## **ADDENDUM NO. 01**

**Project:** Stuhr Museum of the Prairie Pioneer

**Project No.:** L11019

**Date:** 01-23-14

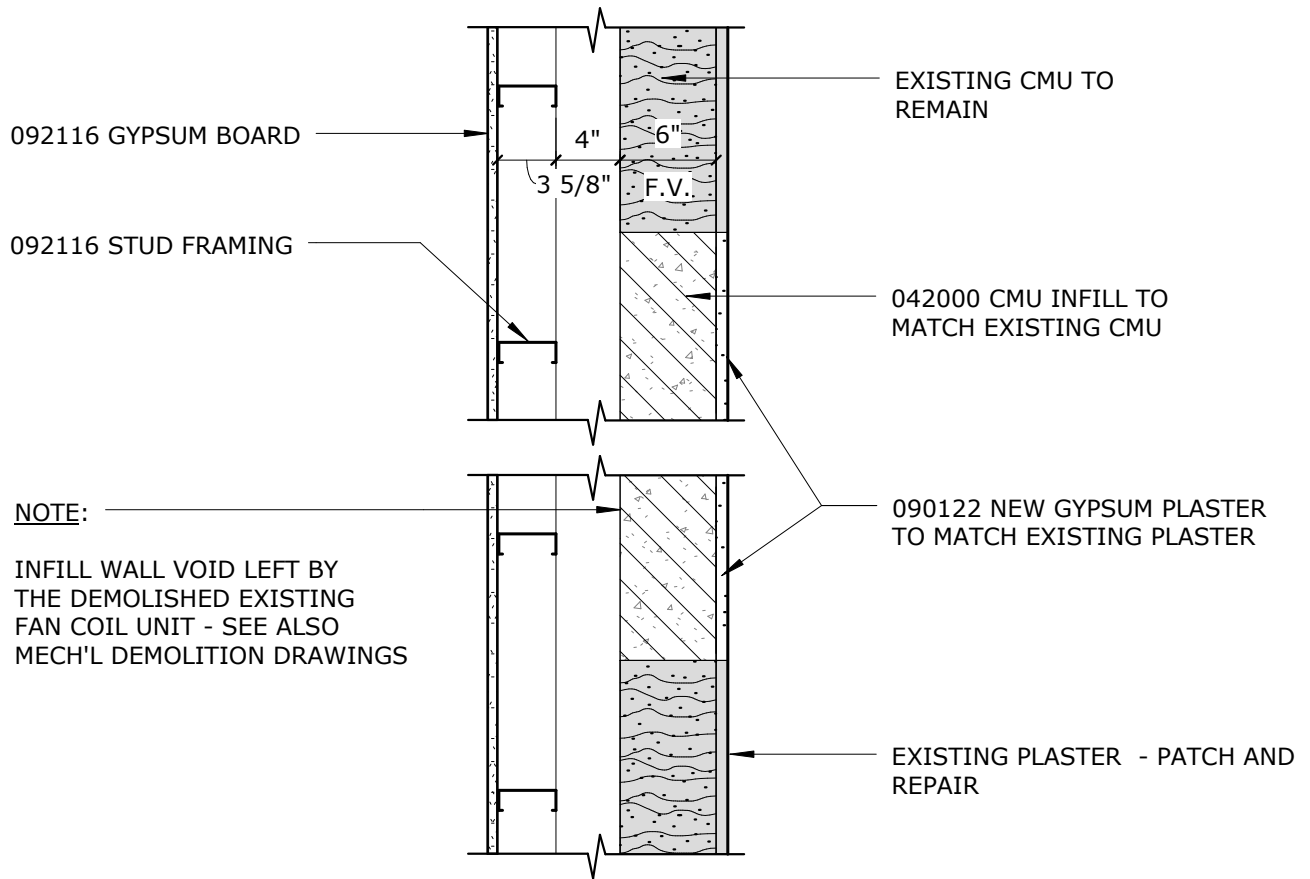
3. See Drawing Attachment “1” for new Plan Detail Referenced on Sheet A1.1
4. See Drawing Attachment “2” for new Plan Detail.
5. See Drawing Attachment “3” for revised Detail drawn on Sheet A3.1.

### 1 WALL SECTION - ADD 1

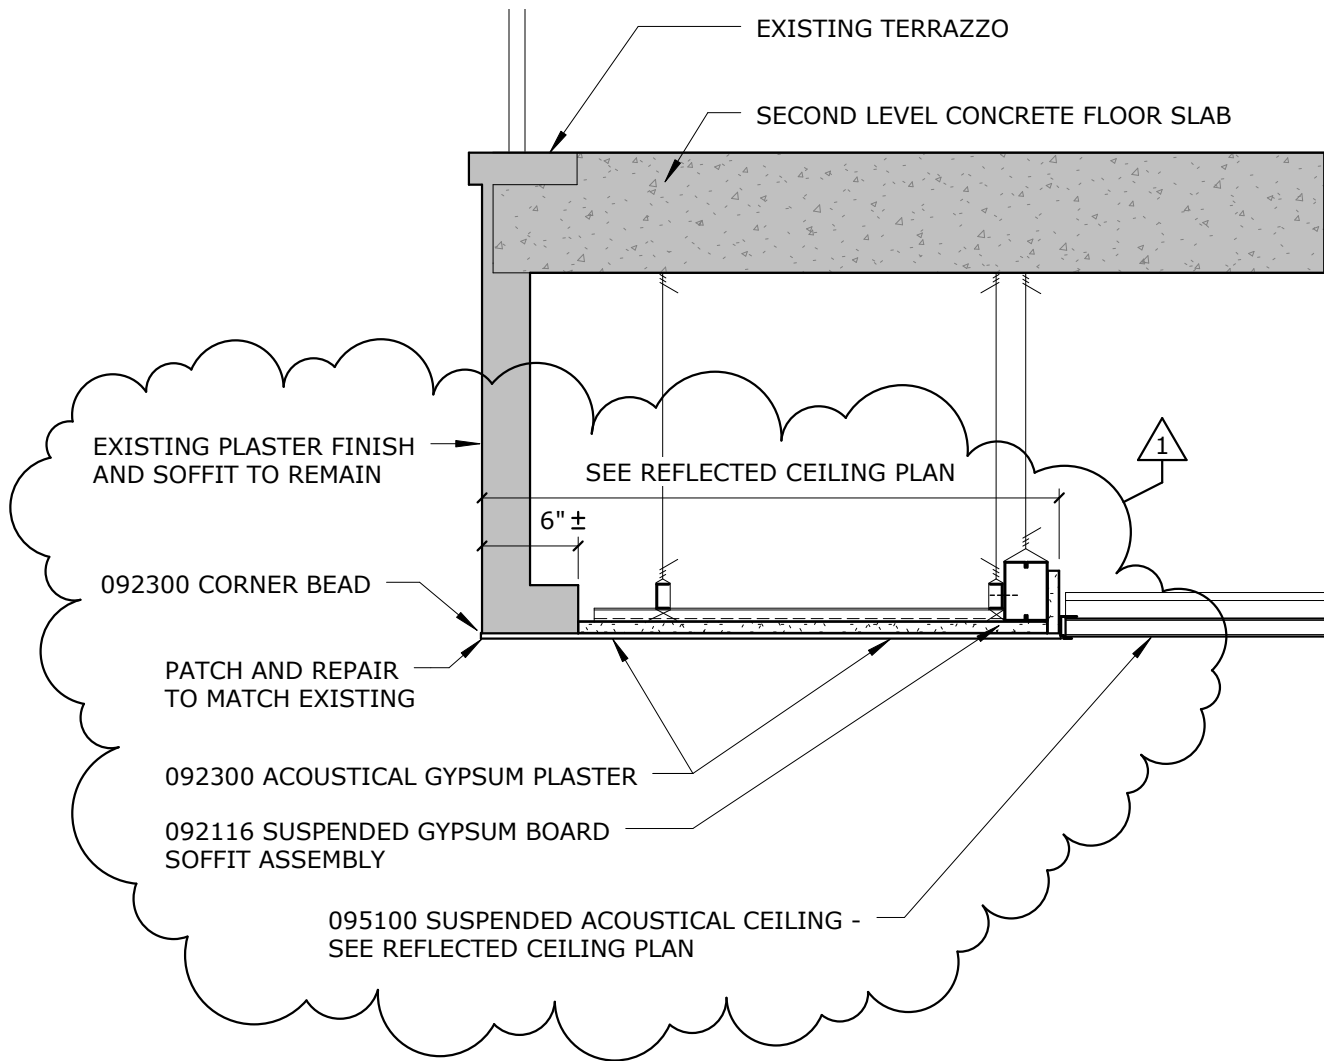
6. See Drawing Attachment “4” for revised Wall Section drawn on Sheet A5.2.
7. See Drawing Attachment “5” for revised Pool Bulkhead Framing Detail drawn on Sheet A8.3.

3/4" = 1'-0" REFER TO SECTION A12 ON SHEET A5.2
